Service Bulletin Nº 95A	
Joe Blackwell Eric Winston Technical Support Manager Technical Support Engineer Tec	Ted Kilpin Jay Alfer echnical Support Engineer Tech. Doc. Administrator
TO: Parts & Service Managers	TOOLS REQUIRED: 1 Ea. Phillips Head Screw Driver
DATE: March 21, 1997 (Updated April 11, 1997)	1 Ea. 1/4" Nut Driver 1 Ea. Drill
SUBJ: Riveted Reed Switch Replacement Kit (Sega Part № 500-6205-00) & Procedure for Riveted Reed Switches	1 Ea. 1/8" (3mm) Drill Bit 1 Ea. 1/4" (7mm) Drill Bit
T H I S K I T C O N T A I N S : 1 Ea. Reed Switch (Tabs on sides, see Switch on Page 2), 2 Ea. #4-40 X 3/8" Phillips Flathead Screw (Non-Magnetic, St 2 Ea. #4-40 Nyloc Stop Nuts (Non-Magnetic, Stainless)	Sega Part Nº 180-5145-01 Stainless) 237-5983-01 240-5303-01

SPECIAT THE STAR WARS TRILOGY E DITTION **Explanation** - We have used Reed Switches for the Ramp Enter (#22 & #24) and Exit (#23) Switches, the Cannon Loaded Switch (#37), the Under Trough Switch (#21) [located under the playfield, below the 4-Bank Drop Target], & the Super VUK Switch (#46) [located on the lower righ side]. **Games prior to Serial Nº 137724** had five (5) of these six (6) switches riveted in place. All but the Supe

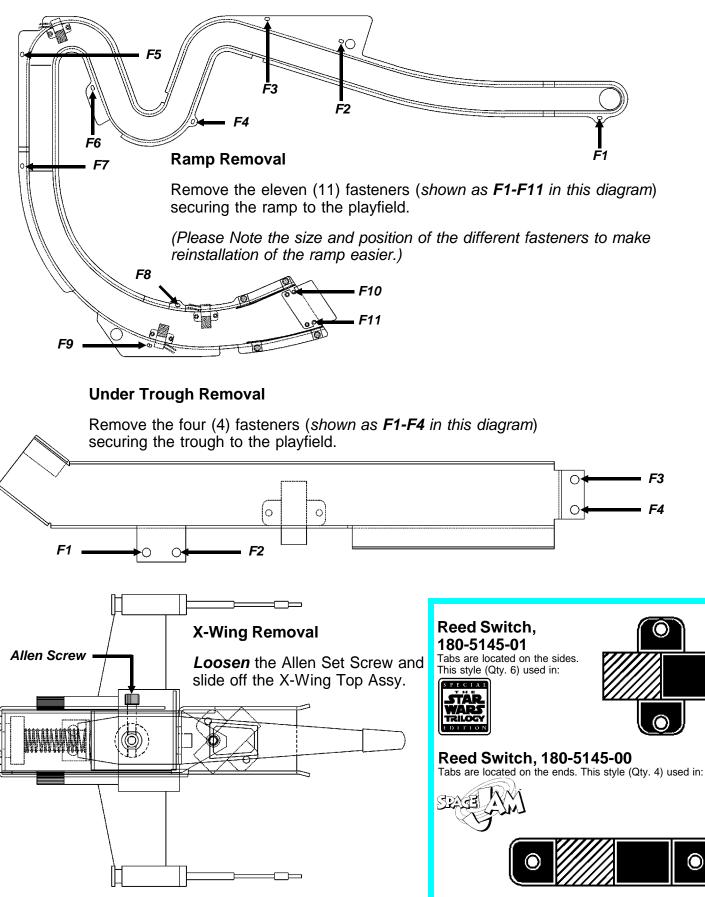
- ① To replace Reed Switches that were originally fastened with rivets, it is necessary to remove the assembly that the Reed Switch is attached to from the playfield (see assembly removal diagrams on the next page).

- ② The rivets are first drilled out using the 1/8" (3mm) Drill Bit (drilling from the side of the rivet **OPPOSITE** the head). It is helpful to set a block of wood or scrap material of some sort (something that you don't mind drilling into) behind the assembly being drilled on to act as a support.

- ③ After both rivets have been removed in this manner, the side of the assembly where the *HEAD* of the rivet was located must be *countersunk* to accept the new fastener (Phillips Flathead Screw) by using the 1/4" (7mm) Drill Bit. Care must be exercised during this countersink drill so as to only enlarge to the depth needed to seat the new machine screw flush or slightly below the level of the material, and not to over-drill all the way through the material being reworked.

- ④ After the proper countersink level has been created, install the new Reed Switch using the screws and nuts supplied with this kit. We recommend breaking off the unused mounting tabs prior to mounting the new switch (on plastic ramps, an XACTO or Utility Knife is helpful in removing melted plastic burrs that will tend to remain in the countersunk area or a Round File for metal burrs on the trough assy's.). BE CAREFUL NOT to countersink to too great a depth (just enough for the head of the screw to be flush or hide below the level of the material).
